FALCON SERVICE BULLETIN

FALCON 7X

No 337-R1

REPLACEMENT OF BATTERY 1 NEGATIVE FEEDER

4. APPENDIX: REPLACEMENT OF LH NEGATIVE FEEDER BRACKET (6-fig. 3)

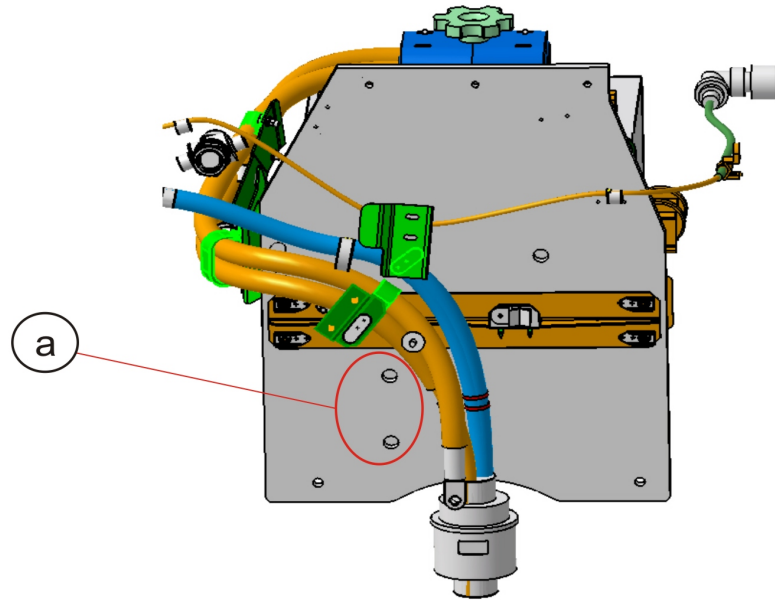
- (1) If new bracket P/N F7XC53555557A1, increase the hole diameter to 10.5 mm (0.414 in).
- (2) Make sure that the new LH negative feeder bracket is spotfaced (face in contact with frame 41).

- (3) Spot the face in contact with the feeder lug (refer to paragraph 2.C.(3)(d)).
- (4) Rim the new LH negative feeder bracket using the 6 pre-drilled holes diameter 2.5 mm (Refer to **SRM 51-40-02**).

- (7) Enlarge holes to 5 mm (0.196 in).
- (8) Pin holes previously enlarged.
- (9) Ream the holes:
 - Remove one pin from a hole,
 - Ream the hole to 5.2 mm (0.2 in) (Refer to **SRM 51-40-03** , paragraph 7.D. ST38150 class of fit (S) "U9".)

Figure 3: INSTALLATION OF LH NEGATIVE FEEDER

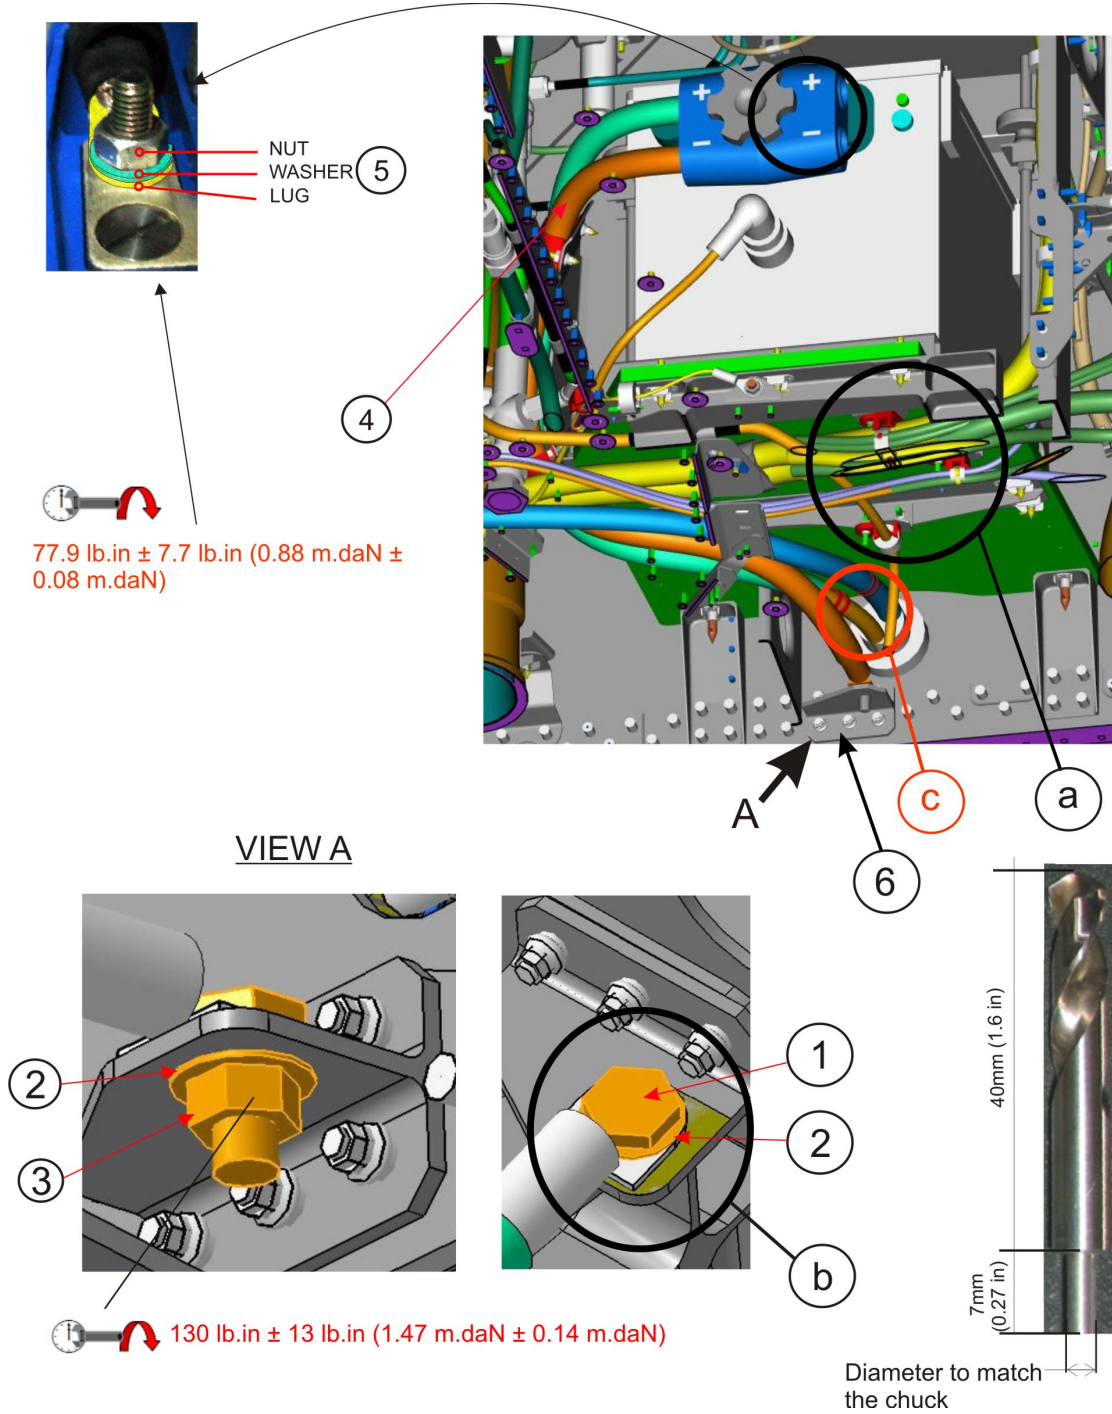
The purpose of this Service Bulletin is to improve the reliability of the connection by increasing the contact surface.

- Replacing the negative feeder of battery 1 with a new feeder which includes a terminal lug with a larger contact surface on the A/C bracket side.
- Cleaning up the A/C bracket by milling.

- (a) In the plug (Refer to **IPC fig. 24-32-10-20**) item 10, install the nut with a new washer and tighten to a torque of 77.9 lb.in ± 7.7 lb.in (0.88 m.daN ± 0.08 m.daN).
- (b) Apply red **torque seal** and close the battery plug.
- (c) On the existing bracket, or on bracket P/N F7XC53555557A1, increase the hole diameter from 8.5 mm to 10.5 mm (0.335 in to 0.414 in) (use the short drill).

- (d) Clean up the bonding area connected to the feeder lug (b-fig. 3).

NOTE: The bracket will be cleaned up by milling around the hole, on the two faces (diameter 24mm (0.945 in)) and on all the contact surface of the lug.

- (e) Install the lug with the new bolt/washers/nut assembly (1-2-3-fig. 3) on its bracket as follows:

CAUTION: MAKE SURE THAT THE CLEARANCE BETWEEN THE NEGATIVE FEEDER AND THE STRUCTURE OR SURROUNDING ELEMENTS IS GREATER THAN 12 MM (0.47 IN)

- (f) Torque the feeder to 130 lb.in ± 13 lb in (1.47 m.daN ± 0.14 m.daN),
- (g) apply red **torque seal** on the nut/washer/bracket assembly,
- (h) apply **vinyl varnish** on all the surface to be protected.
